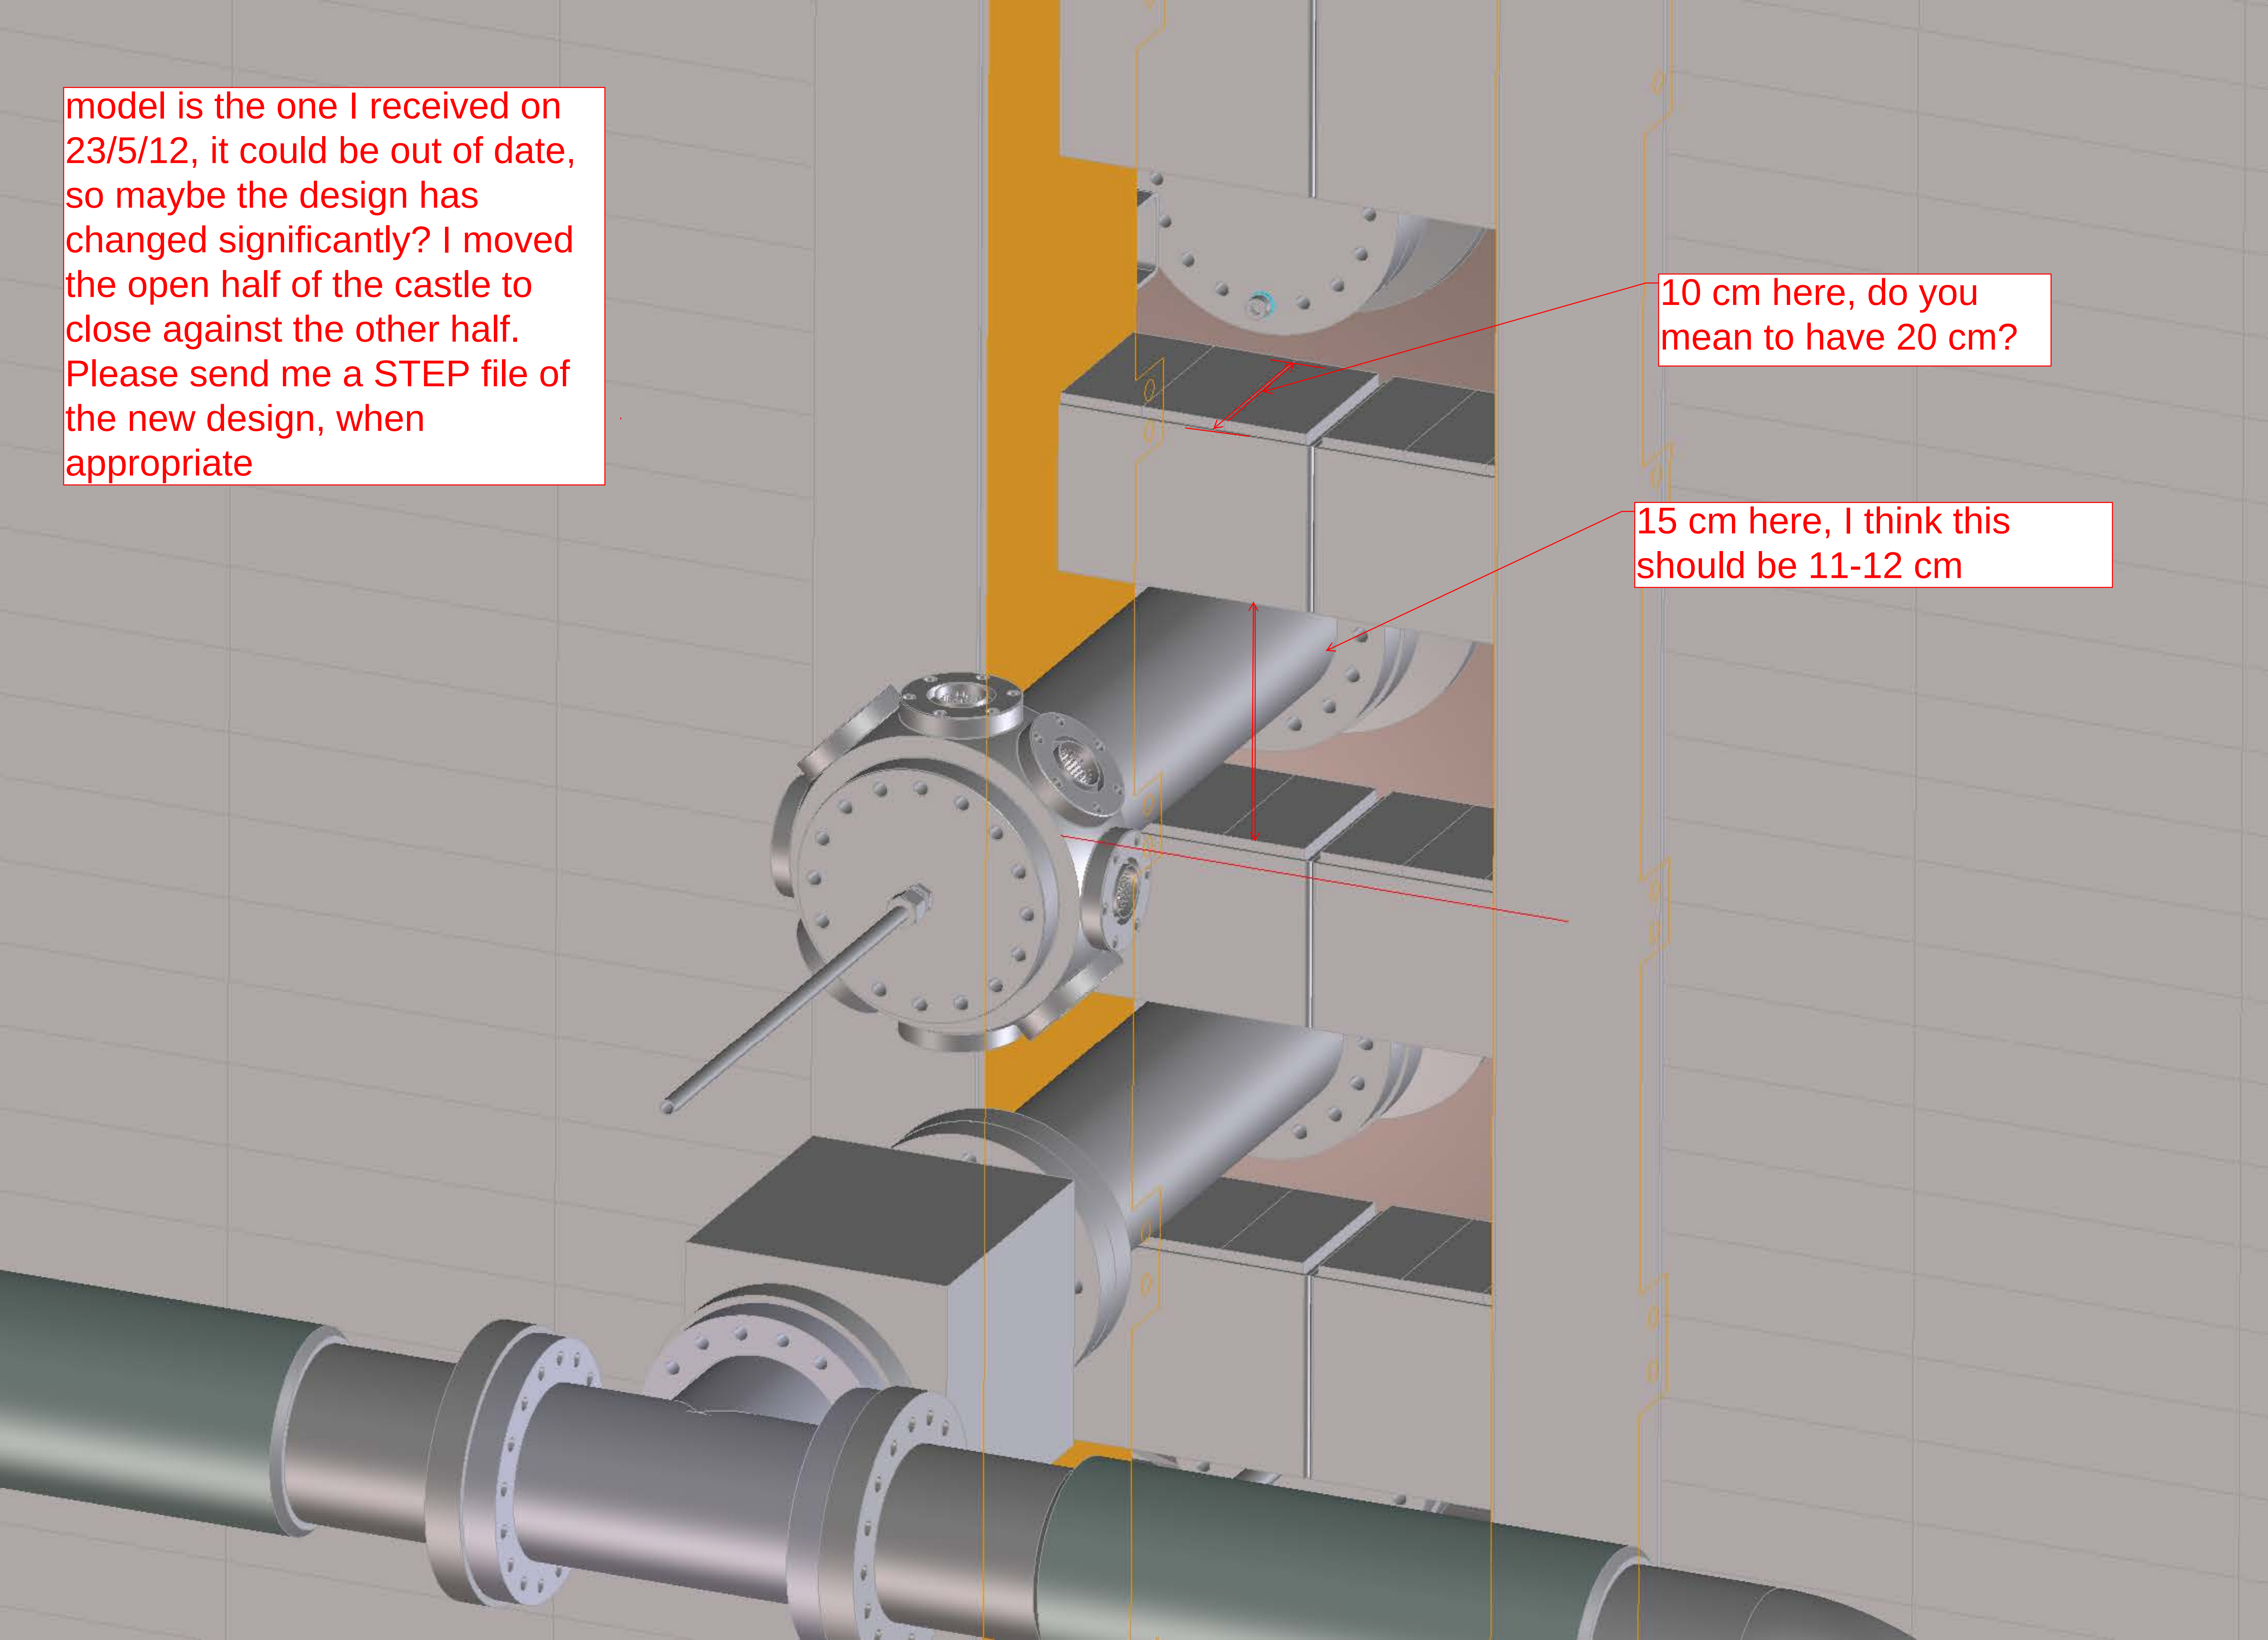
model is the one I received on 23/5/12, it could be out of date, so maybe the design has changed significantly? I moved the open half of the castle to close against the other half. Please send me a STEP file of the new design, when appropriate

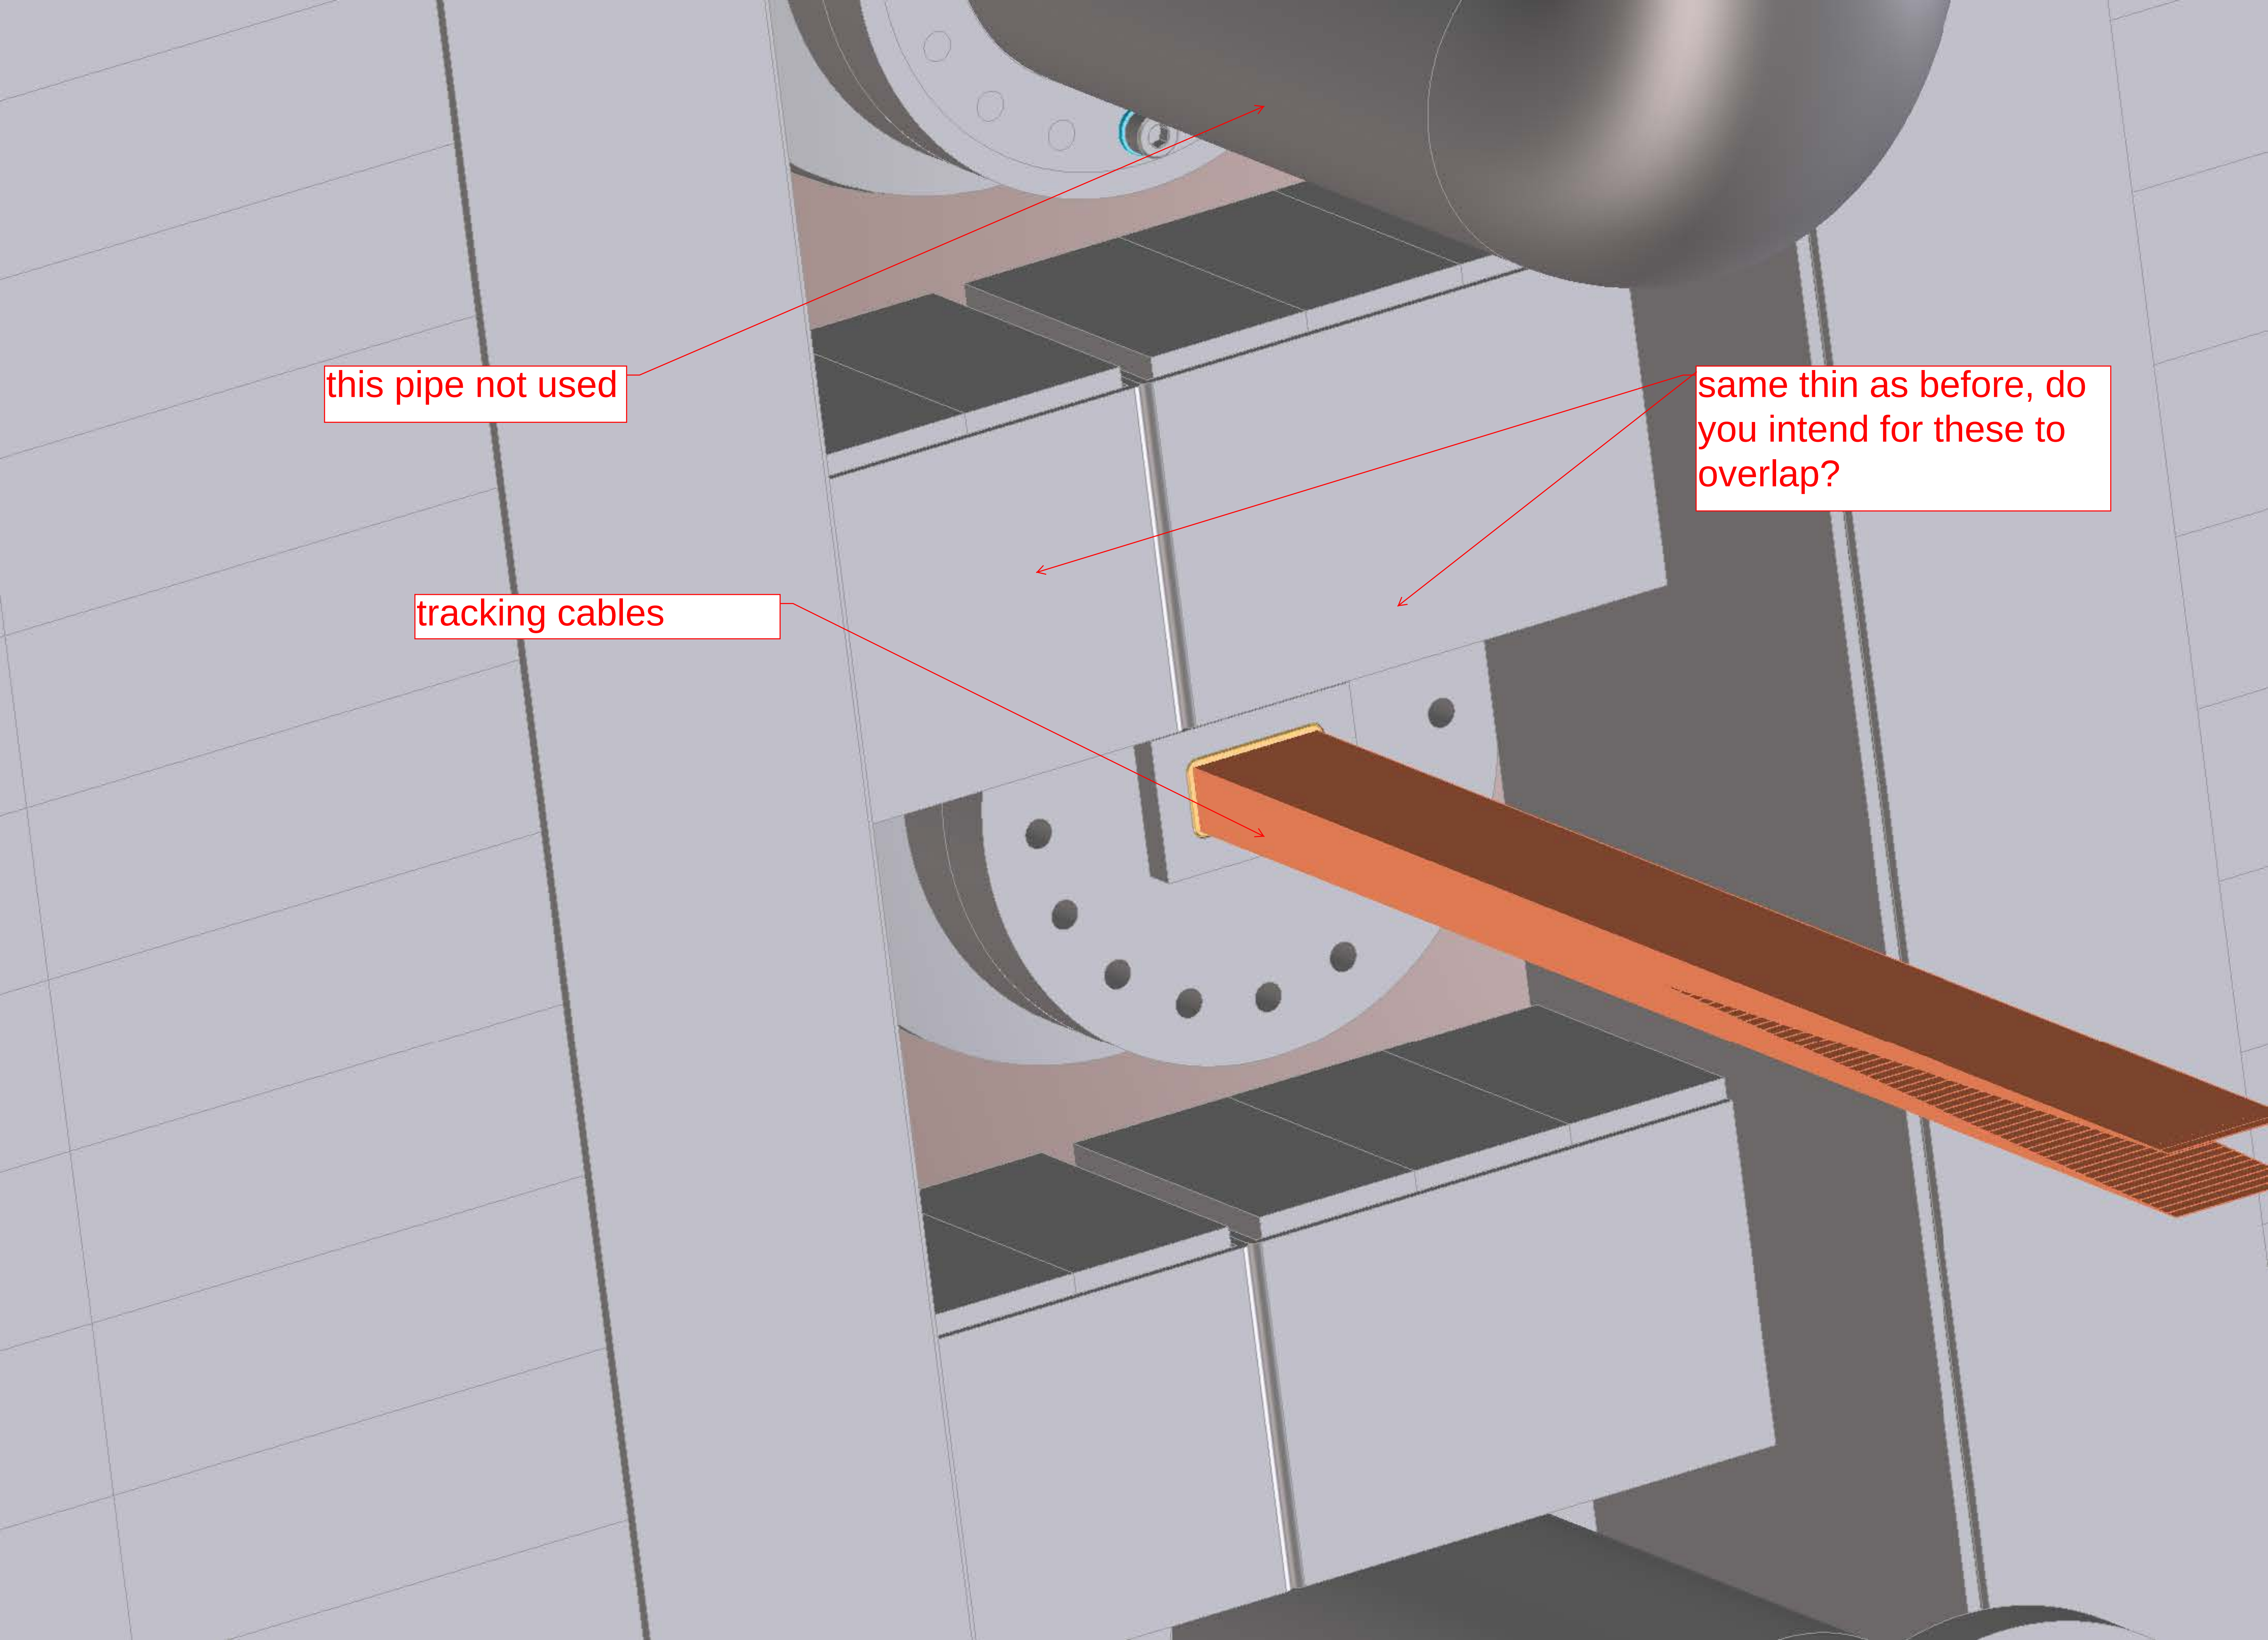
10 cm here, do you mean to have 20 cm?

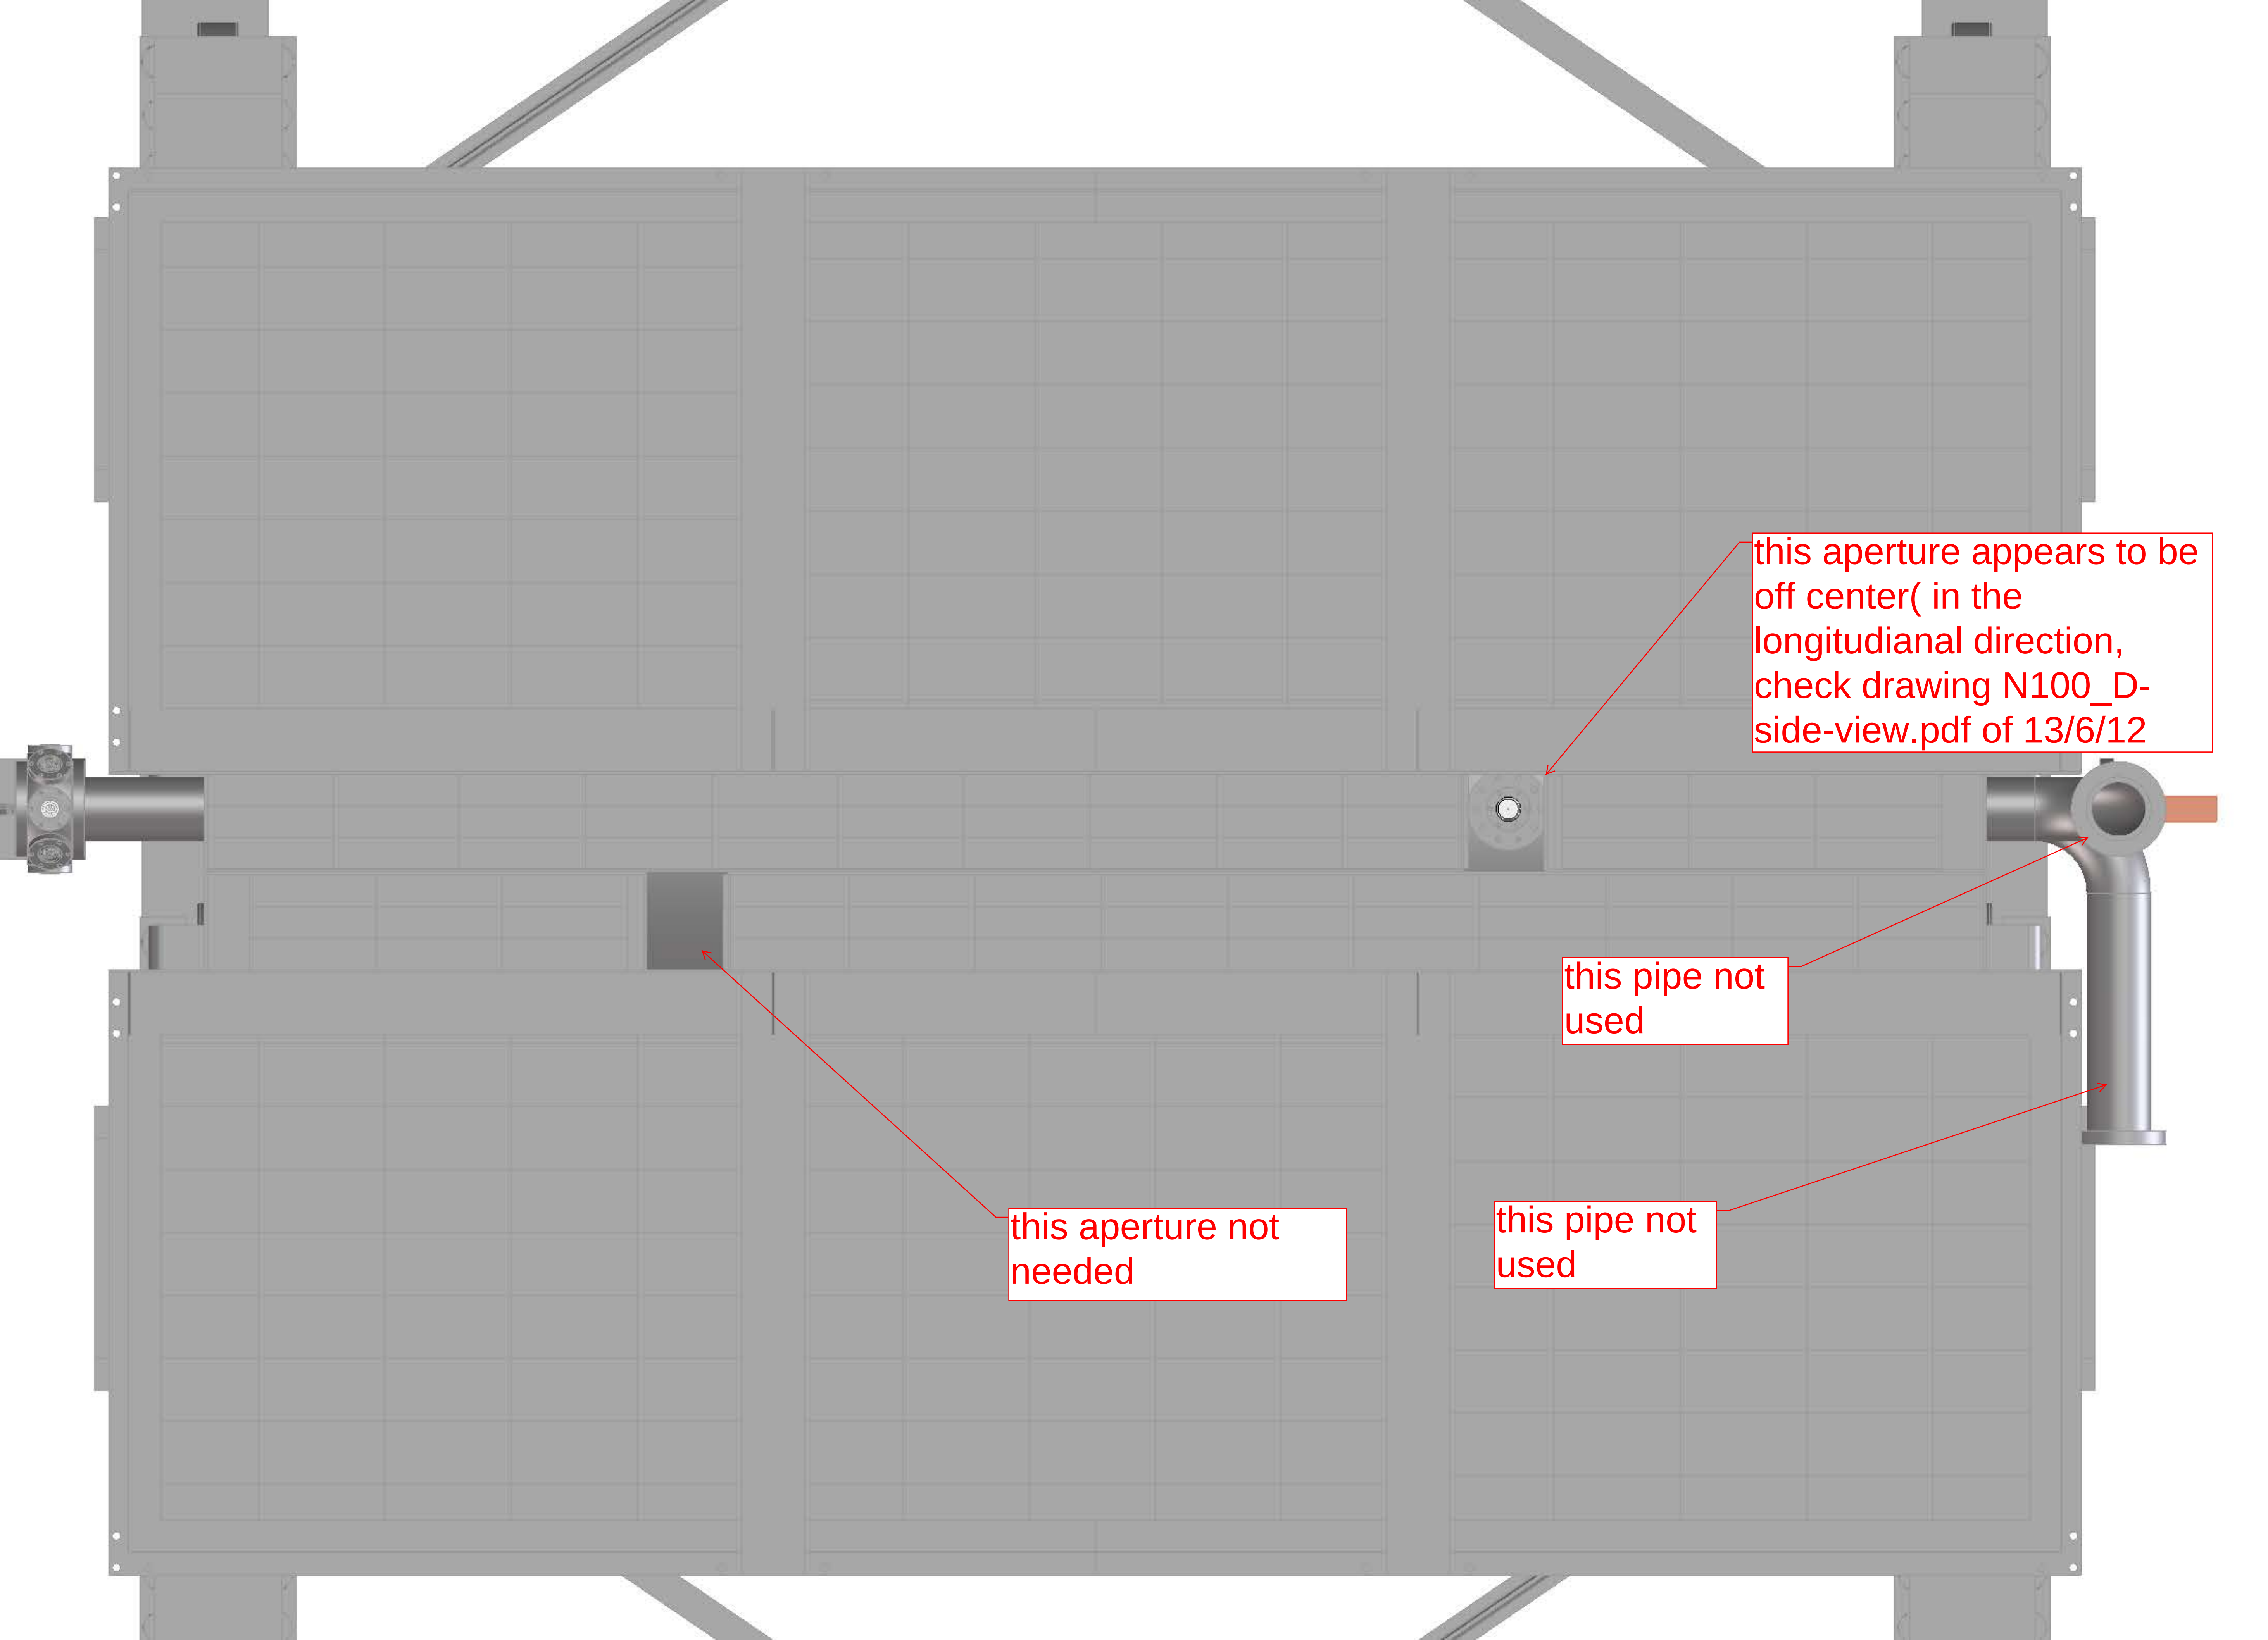
15 cm here, I think this should be 11-12 cm

this pipe not used

tracking cables

same thin as before, do
you intend for these to
overlap?

this aperture appears to be off center(in the longitudinal direction, check drawing N100_D-side-view.pdf of 13/6/12
